Planning Board Meeting AGENDA

Re: Site Plan Application Review Map 7, Lot 39 and 39-1 Warner, New Hampshire

Jennesstown Manor Site Plan Application Tax Map 7, Lots 39 & 39-1 – Warner

RESIDENTIAL SITE PLAN JENNESSTOWN MANOR MAP 7; LOTS 39 & 39-1 ROUTE 103 WARNER, NEW HAMPSHIRE

1 5/22/25 PER PB AND AOT COMMENTS
2 9/4/25 PER AOT COMMENTS
3 10/2/25 PER AOT COMMENTS
4 10/31/25 PER ARIES & FIRE COMMENTS DATE: MARCH 25, 2025 **SCALE:** 1" = 40'PROJECT NO: 24-0307-1 SHEET 3 OF 16

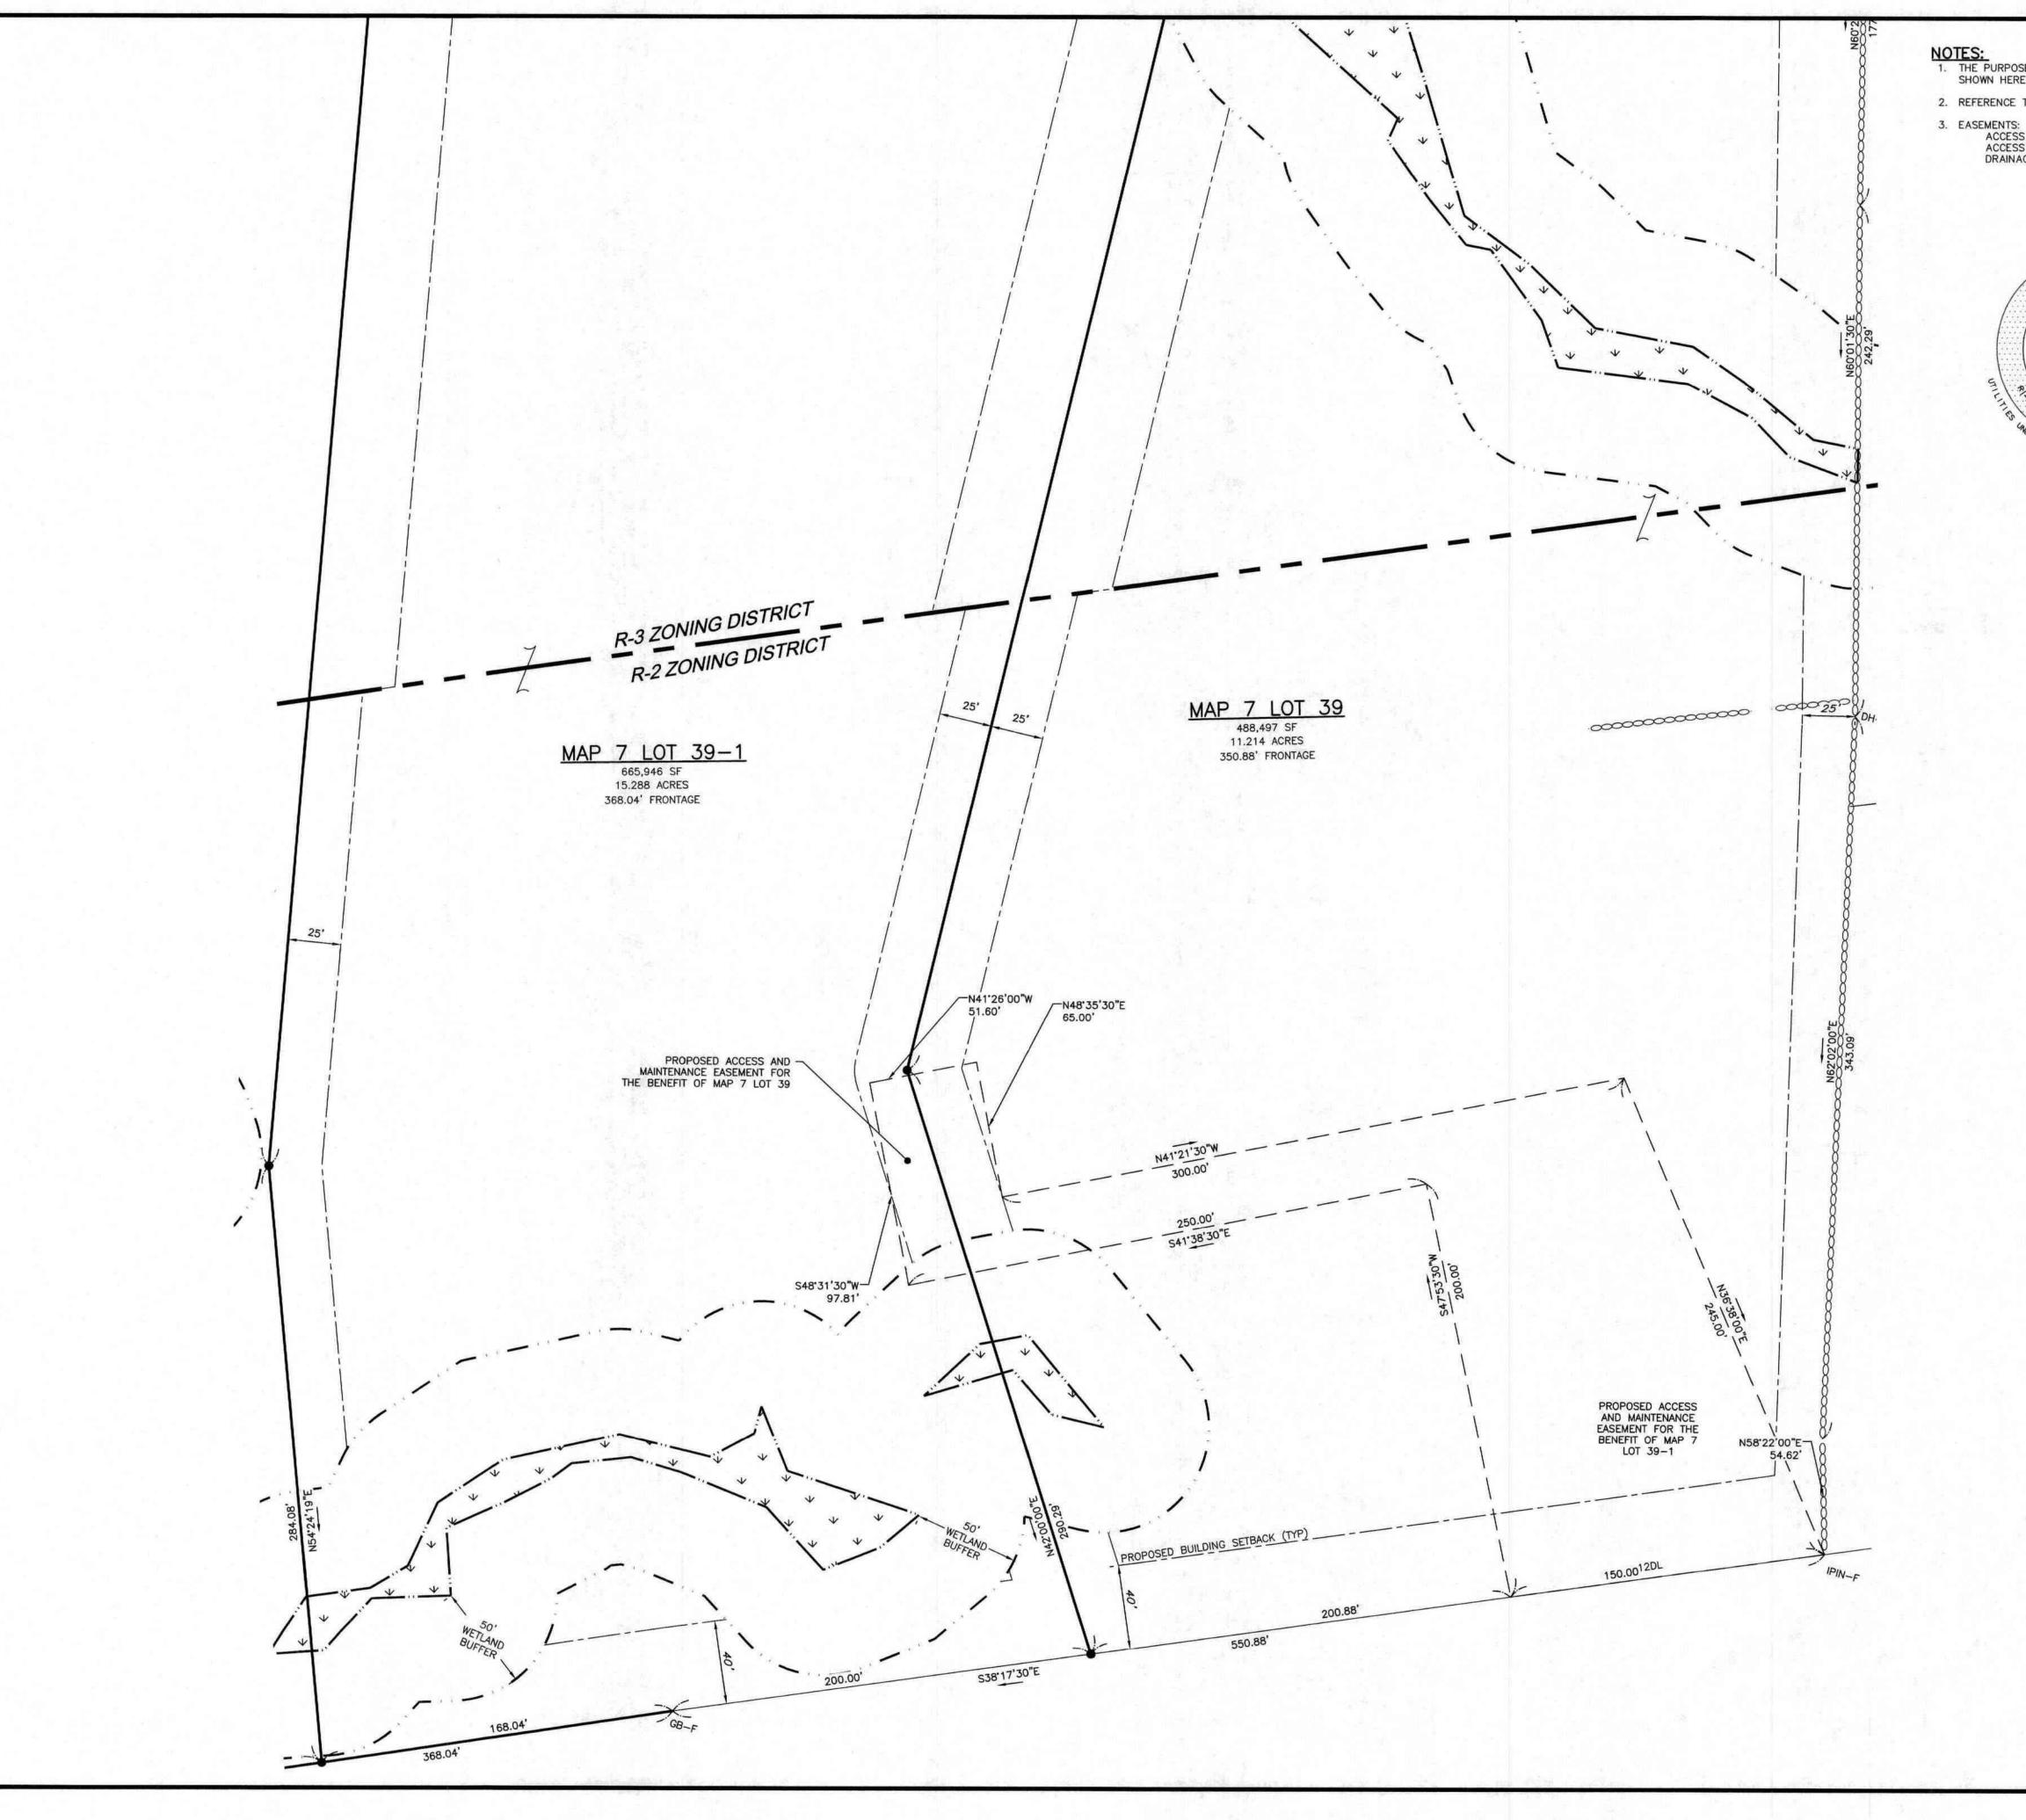
5. The site plans depict a fire truck turnaround and enclosed dumpster located approximately halfway down the proposed steep access road. Based on this location, it is presumed that fire trucks would need to back halfway down the steep access road to turn around. Aries recommends relocating the turnaround and dumpster area adjacent to and at the same level of the dwelling units where both fire apparatus will need to reverse direction and where refuse will be generated. This would provide a second fire truck turnaround.

The Site Plan currently places a fire truck turn-around between the two buildings, as seen on Sheet 3. The location mentioned in this comment is a second location. This location is also shared with the common dumpster location. The Owner/Developer desires to maintain the dumpster in the current location

REVISION	S	
No.	DATE	DESC	CRIPTION	BY
1	5/22/25	PER PB AND AO	T COMMENTS	AEV
2	9/4/25	PER AOT COMME	NTS	AE
3	10/2/25	PER AOT COMME	NTS	AE
4	10/31/25	PER ARIES & FIR	RE COMMENTS	JDI
DATE	E: MARCH 2	5, 2025	SCALE: 1" = 40'	
PRO.	JECT NO: 2	4-0307-1	SHEET 6 OF 16

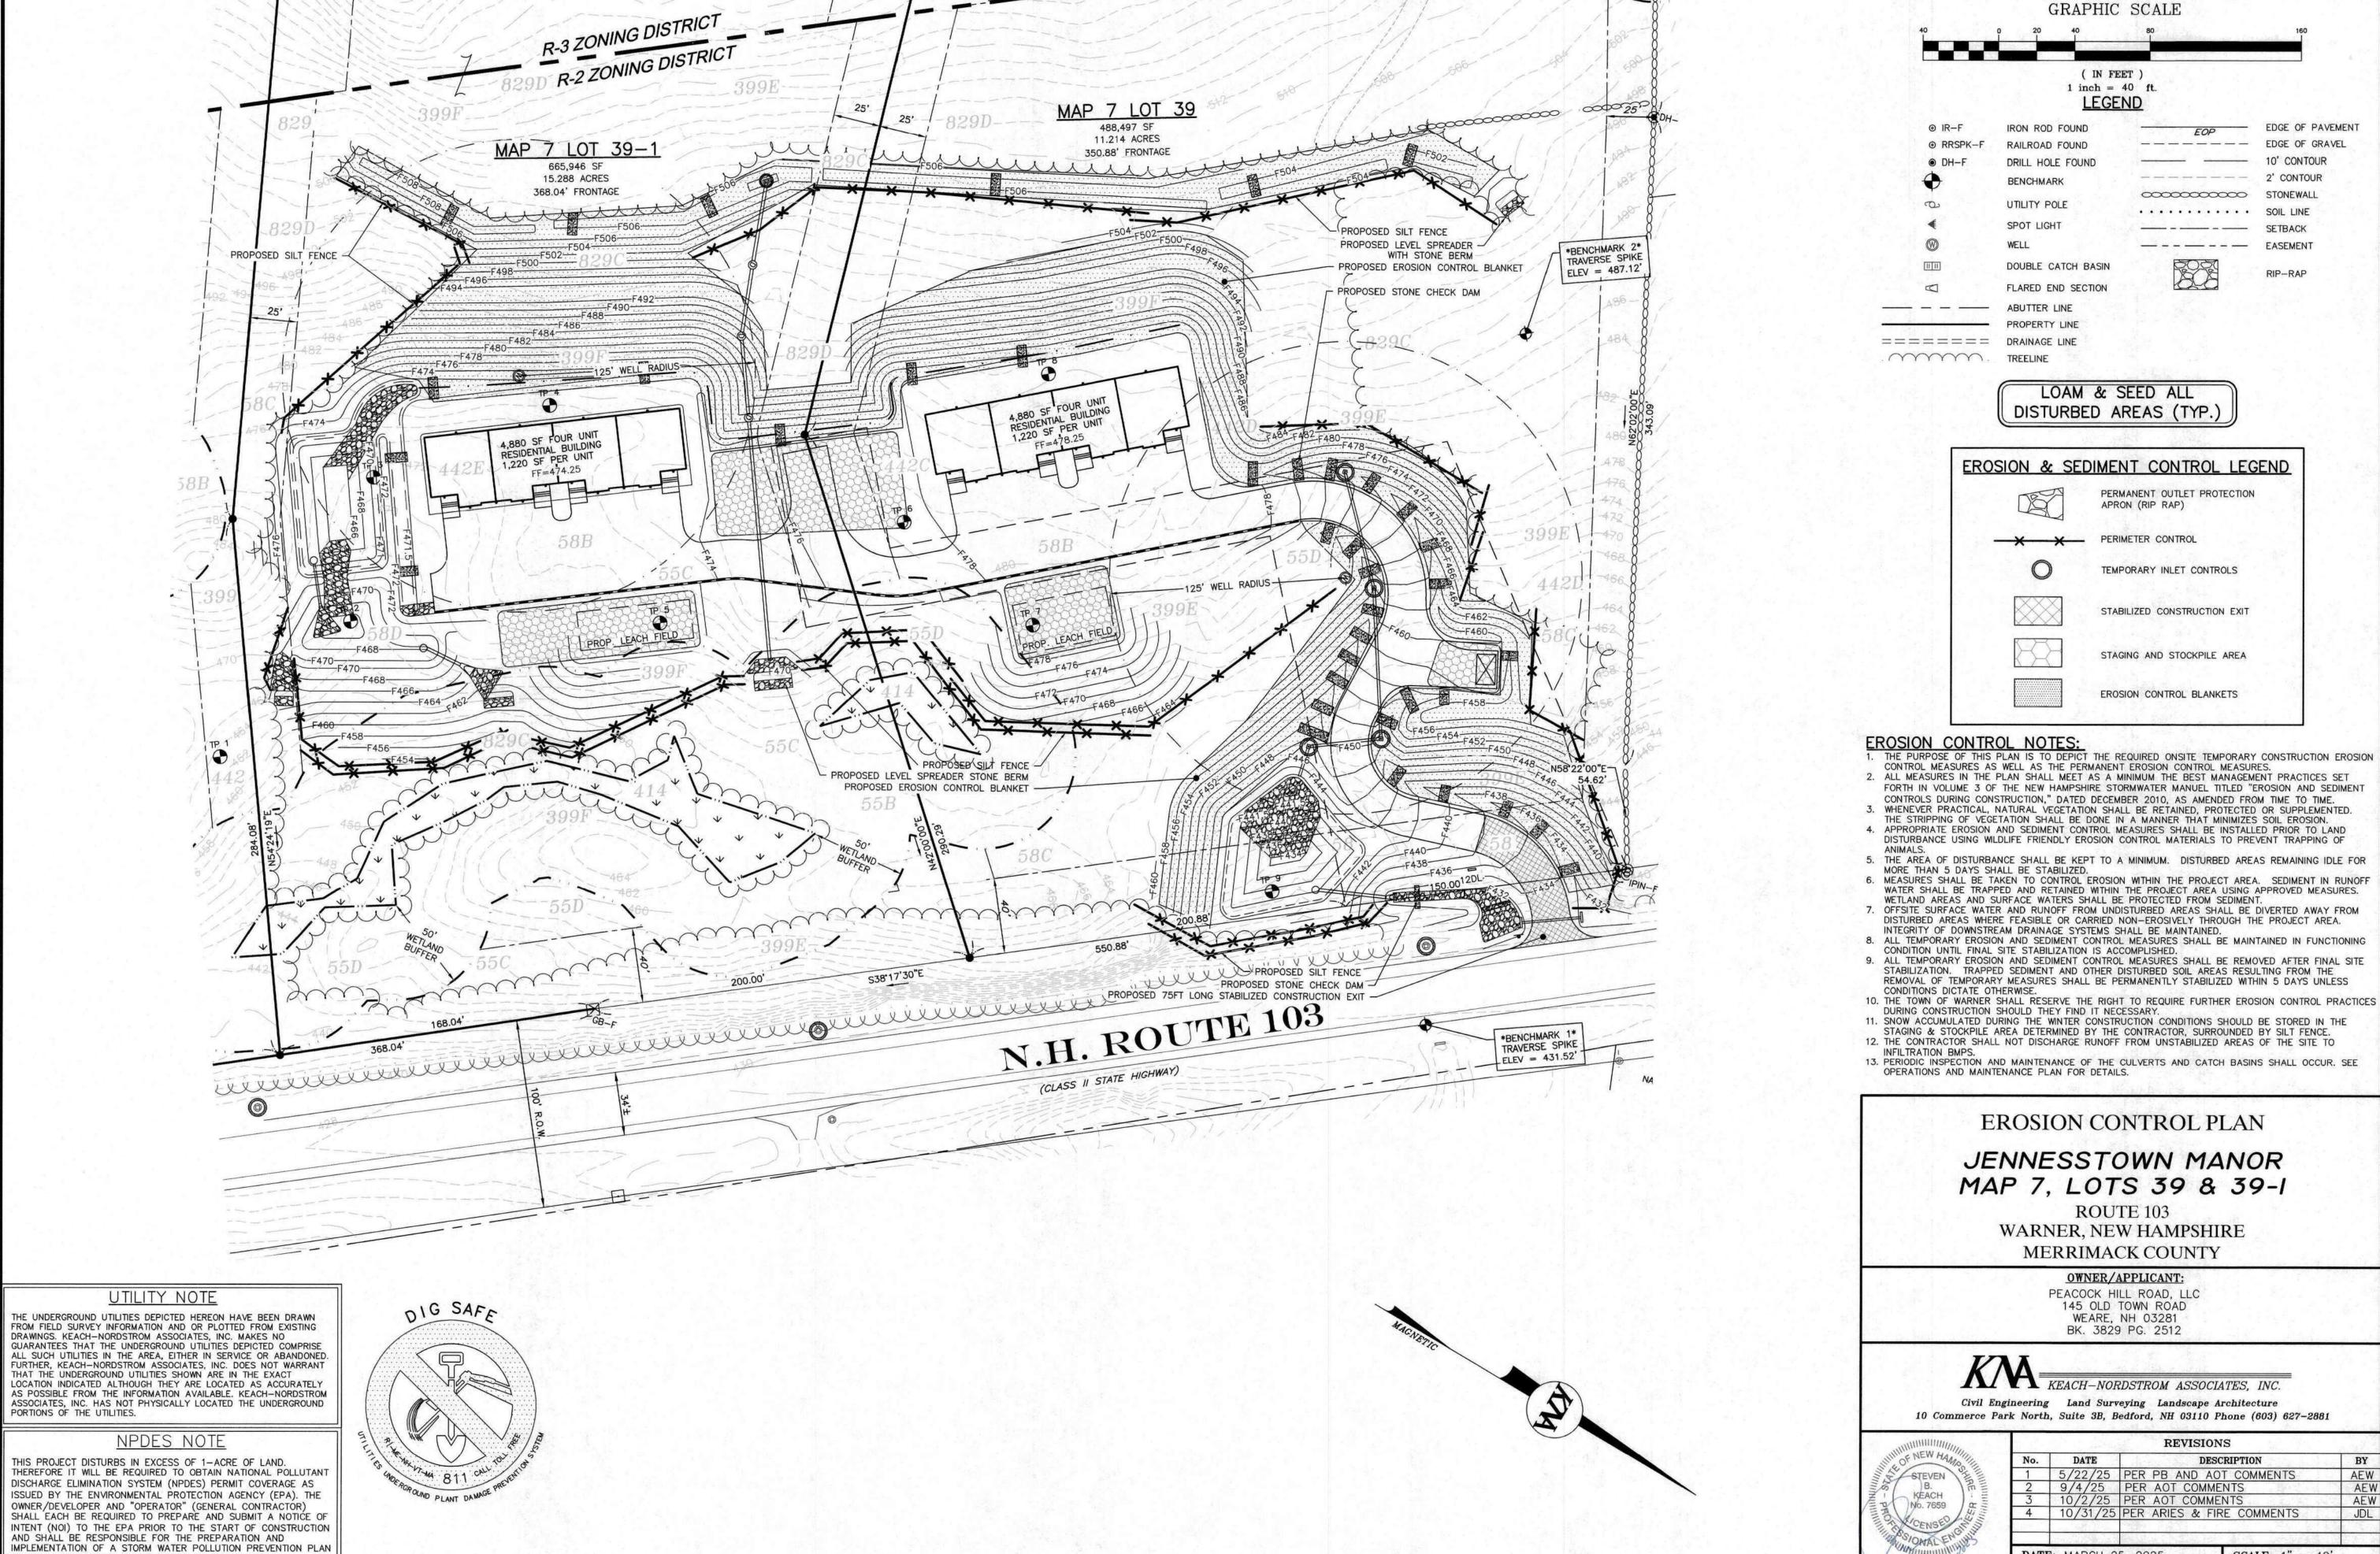
27. Erosion Control notes are provided in the site plan construction details. Aries recommends that the Town conduct periodic inspections to ensure that specified erosion control procedures are followed.

Note 10 on Sheet 6 provides the Town oversight on the placement and function of the erosion control.

LANDSCAPE PLAN

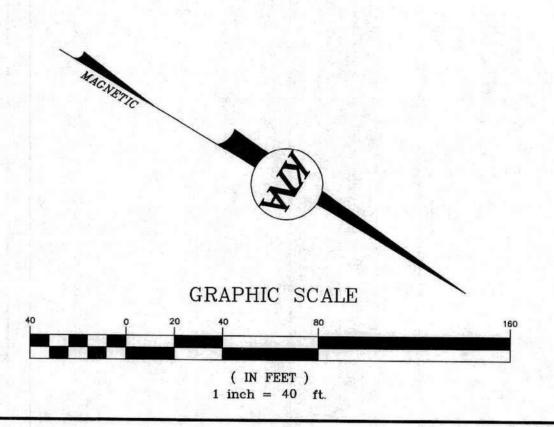
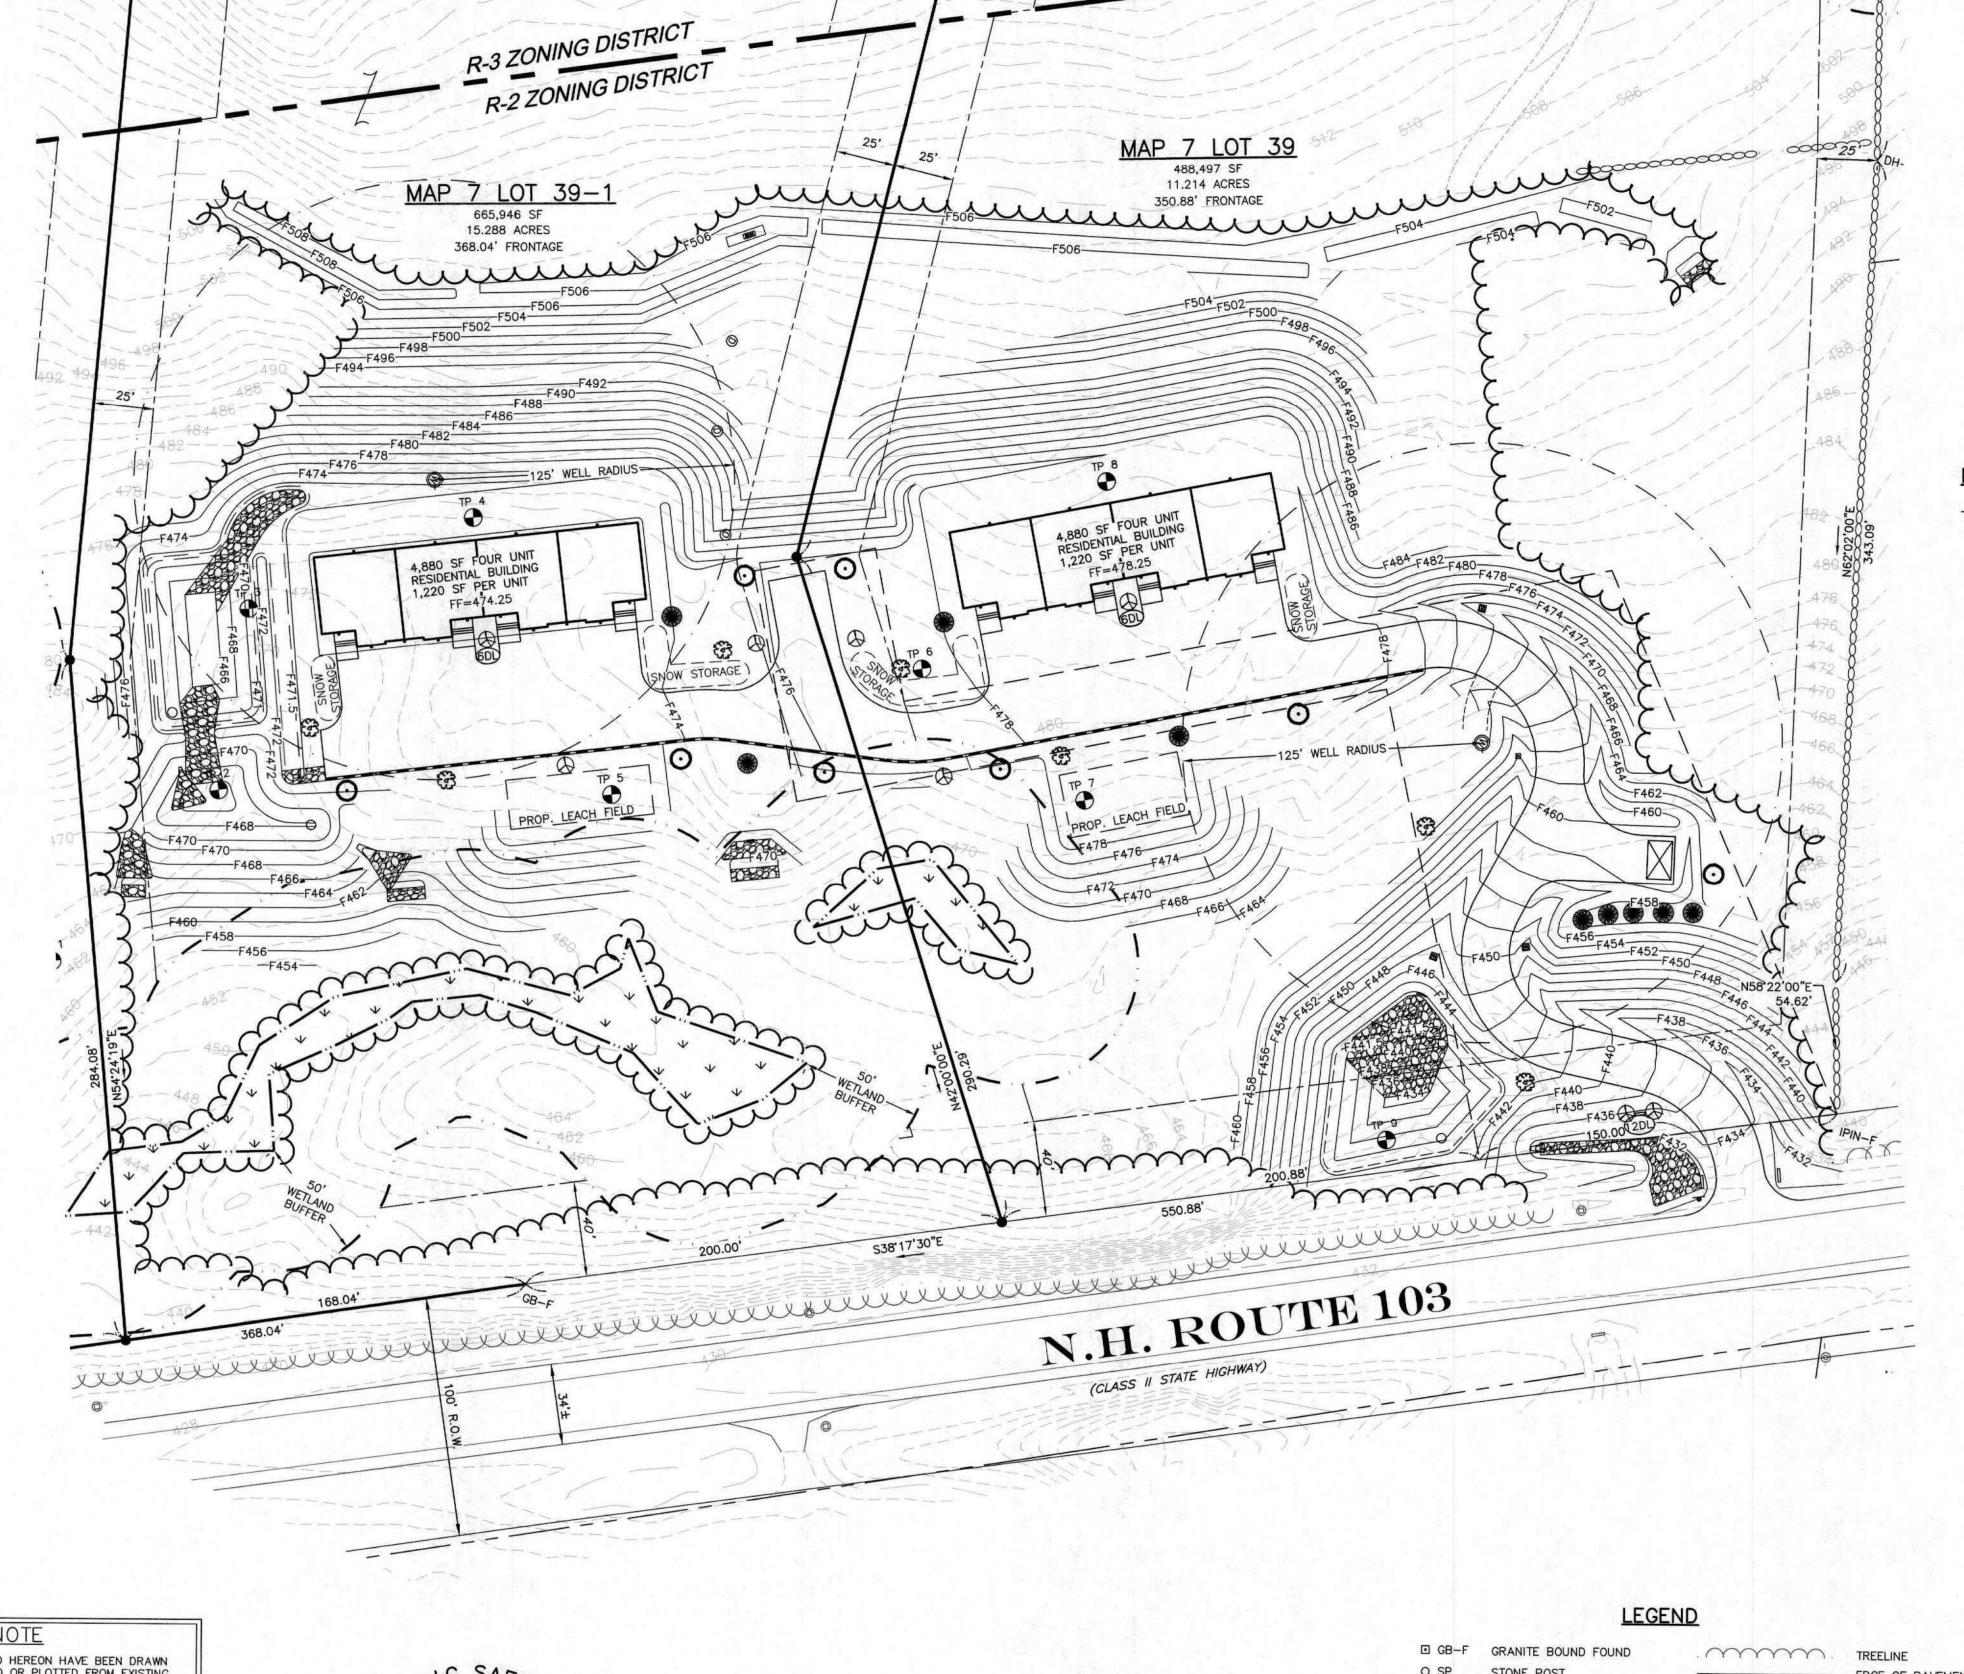
20. Section XVII - Landscaping Standards require a minimum of one 2-1/2" caliper deciduous tree for every 20 parking spaces and every 60 feet of access roads. Available Landscape Plan details list only three deciduous trees to be planted, which does not meet the Town's Landscaping Standards.

The landscape calculations for the deciduous trees have been added to Sheet 7. Twelve additional trees have been added to the plan.
